April 13, 2018

Re: **Data Transmittal**

Clare Central Apartments
1003 and 1033 West Atkinson Avenue
Milwaukee, Wisconsin
Terracon Project No. 58107058A
WDNR BRRTS #02-41-549867
VPLE BRRTS #06-41-560680

MILWAUKEE

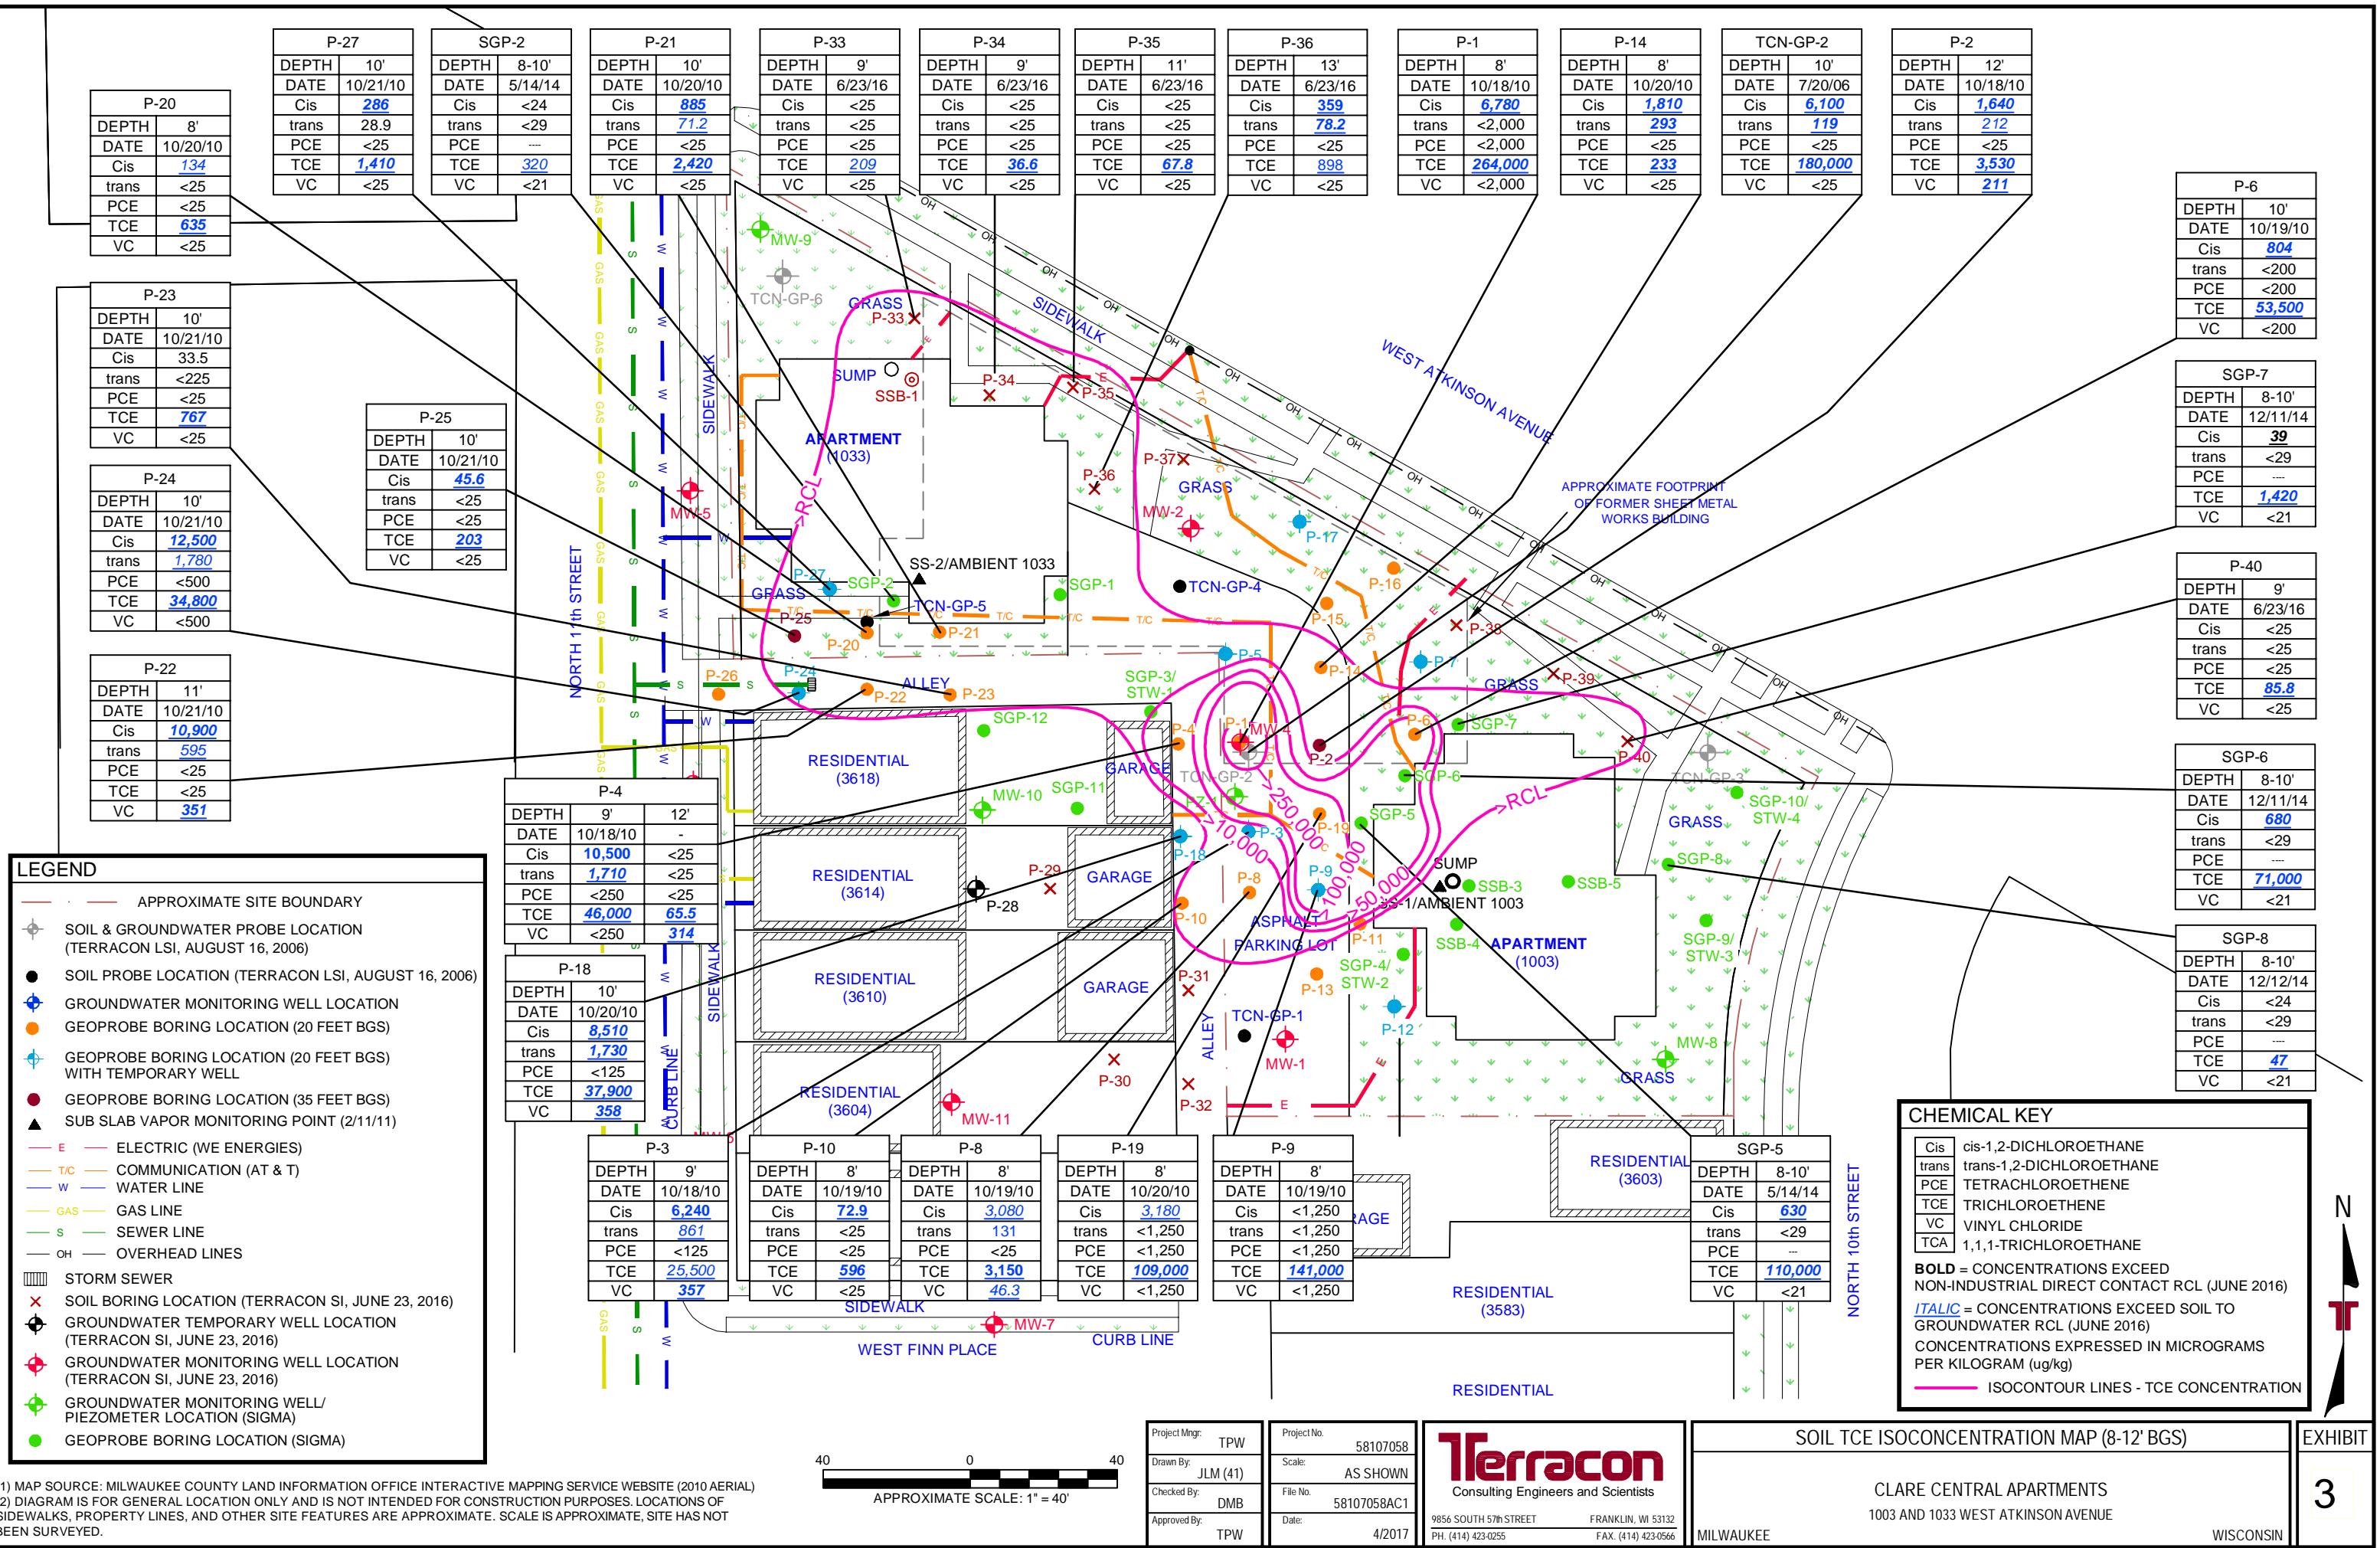
- "It appears that the extent of soil contamination is not defined to the north/northeast beyond soil borings P-33, P-34, P-35, P-39 and P-40. Prepare a brief plan to define the extent of soil impacts in that area".

During the April 2017 meeting, we reviewed the draft soil isoconcentration maps to discuss the further soil delineation to the north/northeast. Borings (P-33, P-34, P-35, P-39, and P-40) are located within 5 to 15 feet from the property line. The property line is adjacent to the concrete sidewalk, which borders West Atkinson Avenue. Trichloroethene (TCE) was detected at concentrations above its soil to groundwater pathway residual contaminant level (RCL) in borings P-33, P-34, P-35, P-39, and P-40; however, the detected concentrations are below its non-industrial, direct-contact RCL. The RCL exceedances are significantly lower than concentrations in soil in the interior of the site. The data indicates a significant source area behind the former wire building in the interior of the site; with

groundwater flow generally to the southwest in this portion of the site, it is unlikely the TCE migrated with groundwater. Rather, Terracon believes the TCE concentrations in soil near the north/northeast property line may have migrated via diffusion from the source area in the soil gas until a stabilized condition was achieved. Given the presence of underground utilities and West Atkinson Avenue, which make further sampling to the north/northeast unsafe, and the decreased concentrations near the property line relative to the source areas, we believe it was appropriate to extrapolate the extent of the soil isoconcentration line to the north/northeast, rather than pursuing off-site sampling. Furthermore, it was discussed that because of other potential sources of chlorinated solvents in the area, off-site soil data may be difficult to interpret as it relates to the site. Specifically, the February 2014 Phase I Environmental Site Assessment (ESA) report identified the following four potential off-site sources of chlorinated solvents:

A Site Plan Map (Figure 2 from the Phase I ESA), CVOC and TCE isoconcentration maps (Exhibits 1 through 3), and tabulated, historical soil analytical results (Table 1) are attached.

GROUNDWATER CONTOUR MAP (5/11/2017)
CLARE CENTRAL APARTMENTS
1003 AND 1033 WEST ATKINSON AVENUE
MILWAUKEE
WISCONSIN
EXHIBIT 4

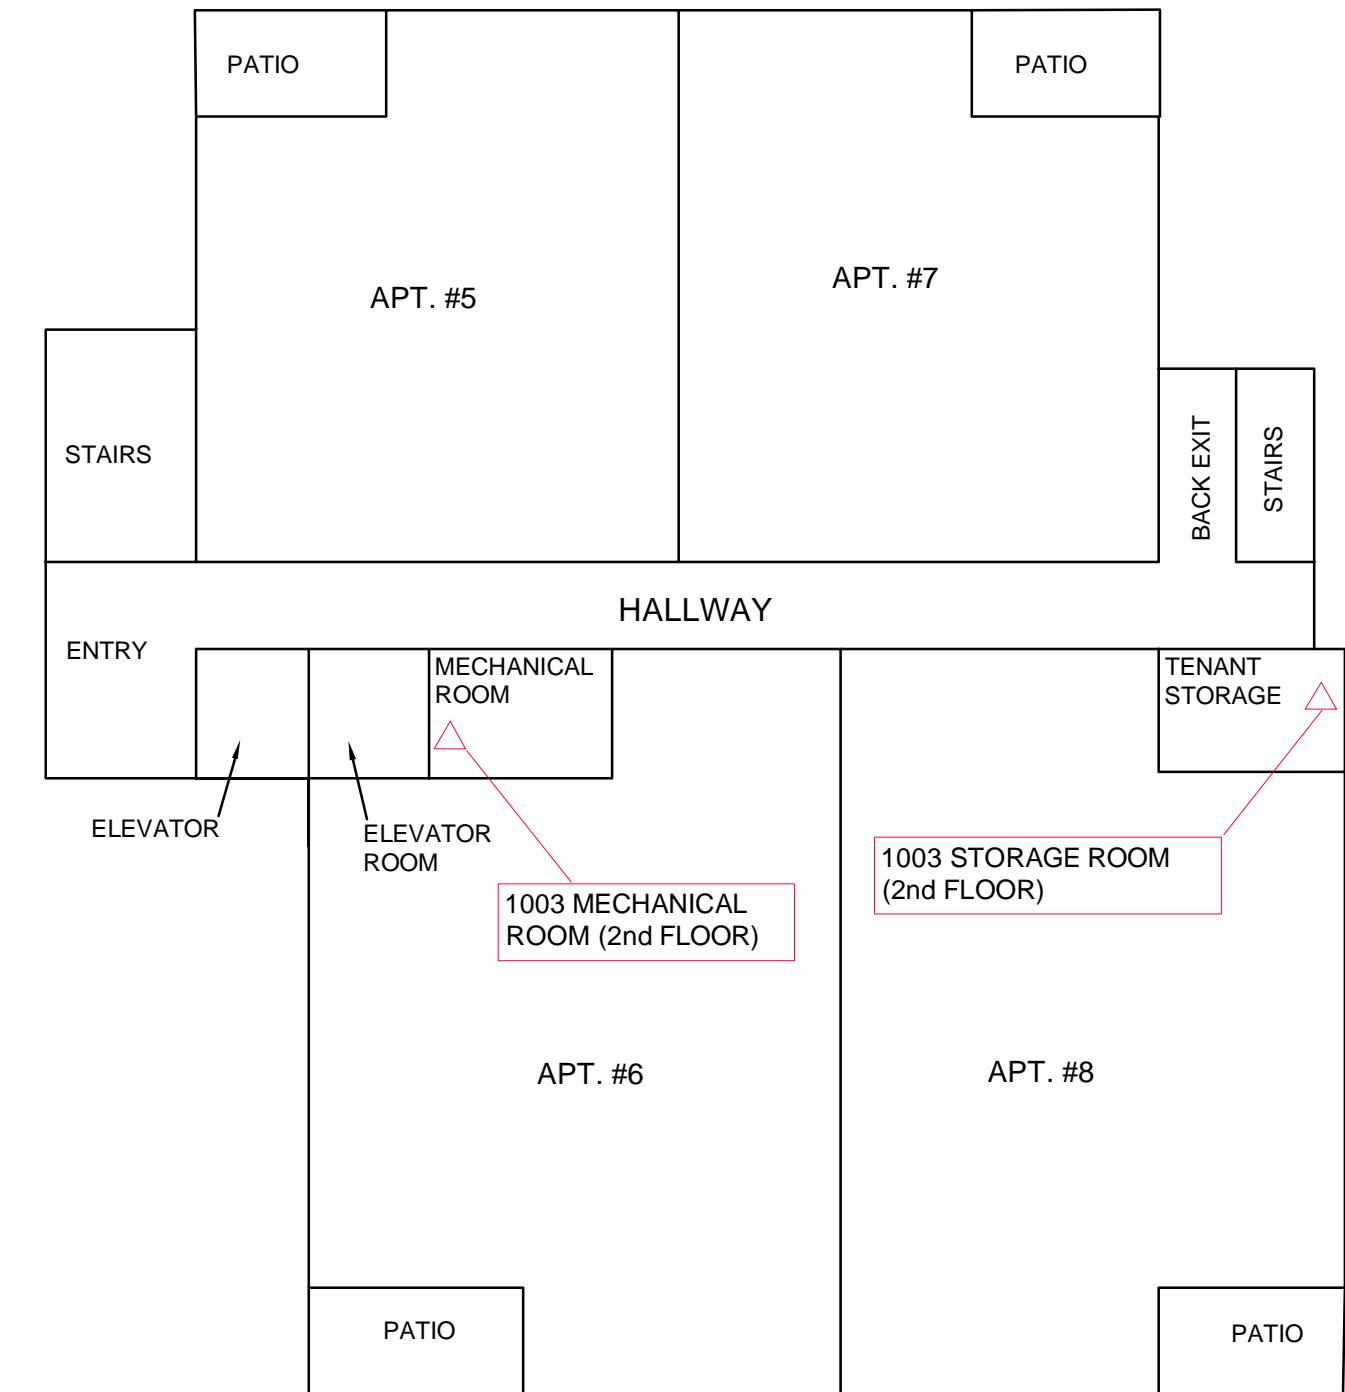
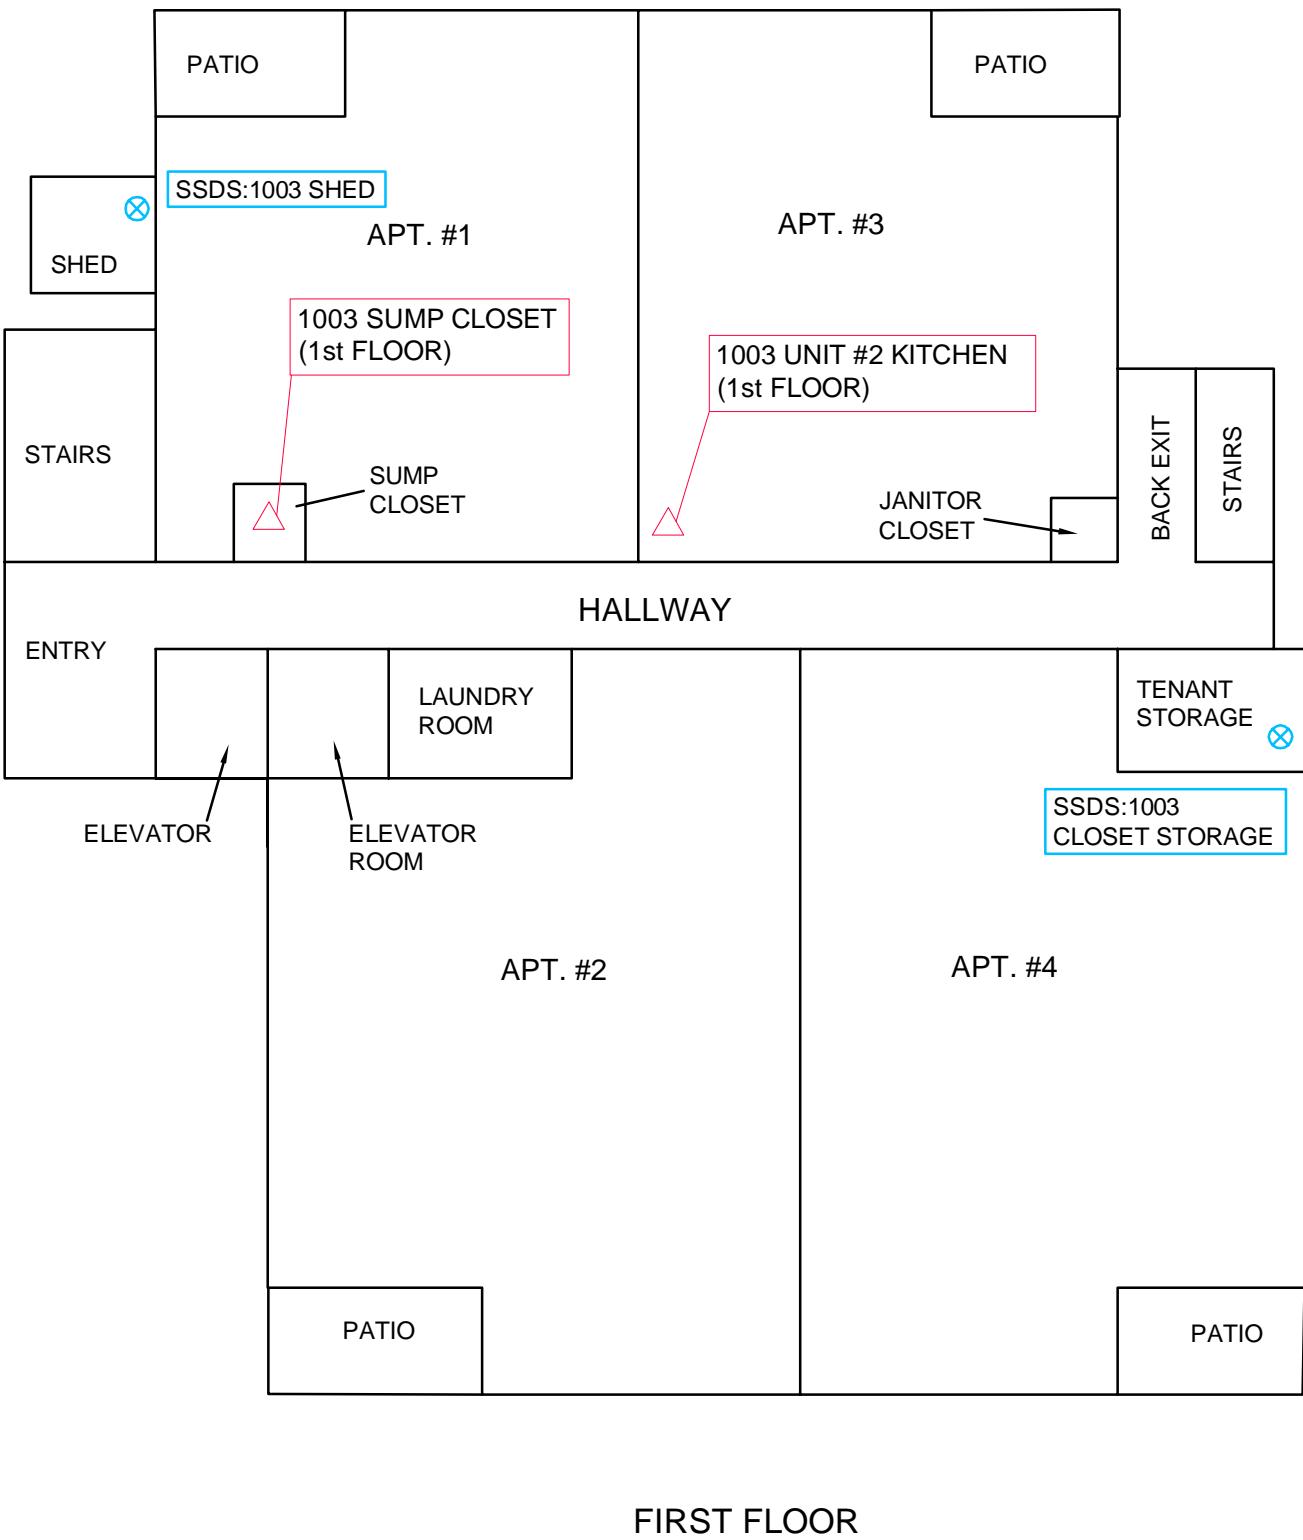
- “The newly acquired soil data (samples apparently collected below water table) indicate that there could be a component of groundwater flow to the north/northeast. Sample all monitoring wells except MW-4 for volatile organic compounds (VOCs). Measure groundwater elevations in all wells and prepare a groundwater flow map”.

On May 11, 2017, Terracon personnel measured static water levels and collected groundwater samples from the groundwater monitoring well network. The groundwater samples were collected using low-flow sampling methods, to reduce the potential for sample turbidity, and were submitted for laboratory analysis of VOCs by USEPA Method 8260B. The groundwater samples were collected in laboratory-supplied containers, placed in an ice chest to cool to approximately 4°C, and transferred under chain-of-custody protocol to a Wisconsin-certified laboratory for analysis. A duplicate and trip blank were also submitted for VOC laboratory analysis. Static water levels ranged from 0.77 feet (MW-1) to 8.53 feet (MW-3) below top of casing. Groundwater was mounded at monitoring well MW-1, with some radial flow east toward monitoring well MW-8. Groundwater flow was variable on site, but generally to the west/northwest near monitoring wells MW-2 and MW-4, where chlorinated VOCs (CVOCs) have been historically detected at concentrations above NR 140, Wisconsin Administrative Code (WAC), Enforcement Standards. The results of the sampling identified the vinyl chloride (VC) concentration in the groundwater sample collected from monitoring well MW-2 above its NR 140, WAC, ES, consistent with historical analytical results. VOCs were not detected at concentrations above analytical limits of detection in groundwater samples collected from the other groundwater monitoring wells and piezometer (monitoring well MW-4 was not sampled). Groundwater elevation data is presented on the

attached Table 2, a summary of groundwater analytical tests results is presented on the attached Table 3, and a Groundwater Contour Map (5/11/2017) is presented as Exhibit 4.
